**Technical Service Bulletin (TSB)**  
**Improperly Installed Wastegate Rod Retention Clips**

<b>REFERENCE:</b>	<b>TSB:</b> 09-008-25 <b>GROUP:</b> 09 - Engine	<b>Date:</b>	April 16, 2025	<b>REVISION:</b>	—
<b>VEHICLES AFFECTED:</b>	<b>2025 (DT) RAM 1500 Pickup</b> This bulletin applies to vehicles built on or after June 01, 2024 (MDH 0601XX) and on or before March 03, 2025 (MDH 0325XX) equipped with the 3.0L I6 Hurricane HO Twin Turbo ESS (Sales Code EFC).	<b>MARKET APPLICABILITY:</b>		<input checked="" type="checkbox"/> NA	<input type="checkbox"/> MEA
				<input type="checkbox"/> EE	<input type="checkbox"/> IAP
				<input type="checkbox"/> SA	<input type="checkbox"/> CH
<b>CUSTOMER SYMPTOM:</b>	<p><b>Customers must experience a Malfunction Indicator Lamp (MIL) illumination and the vehicle must exhibit/set one or more of the following Diagnostic Trouble Codes (DTCs):</b></p> <ul style="list-style-type: none"> <li>• P0248-00 - Turbocharger-Supercharger Wastegate Actuator B Range-performance.</li> <li>• P2B94-00 - Wastegate Position Sensor B Exceeded Learning Limit.</li> </ul> <p><b>Customers may also experience the following:</b></p> <ul style="list-style-type: none"> <li>• Lack o

**Fig. 1**  
Wastegate Rod Retaining Clips

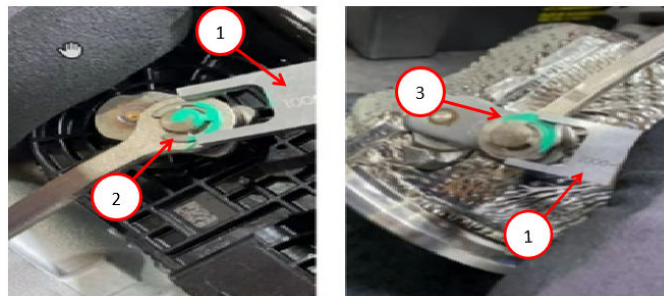
1. Remove the clean air tube. Refer to the detailed service procedures available in DealerCONNECT/Service Library under: Service Info> 09 - Engine, 3.0L GMET6 / Air Intake System / Tube, Intake Air / Removal.
2. Using a caliper, measure the dimensions of the two wastegate rod retaining clips on the actuator side [Fig. 1](#).

3. Is the measurement of either wastegate rod retaining clip on the actuator side greater than 13.70 mm (0.5 in.)?
  - YES>>> Proceed to [Step 4](#).
  - NO>>> Proceed to [Step 5](#).
4. Replace any wastegate rod retaining clip on the actuator side that measures larger than 13.70 mm (0.5 in.).

5. Using a caliper, measure the dimensions of the two wastegate rod retaining clips on the housing side [Fig. 1](#).
6. Is the measurement of either of the wastegate rod retaining clips on the housing side greater than 17.78 mm (0.7 in.)?
  - YES>>> Proceed to [Step 7](#).
  - NO>>> This bulletin has been completed, use Inspect LOP (09-44-03-92) to close this active RSU and proceed to [Step 8](#).
7. Replace any wastegate rod retaining clip on the housing side that measures larger than 17.78 mm (0.7 in.).
8. Install the clean air tube. Refer to the detailed service procedures available in DealerCONNECT/Service Library under: Service Info> 09 - Engine, 3.0L GMET6 / Air Intake System / Tube, Intake Air / Installation.
9. Clear DTCs.
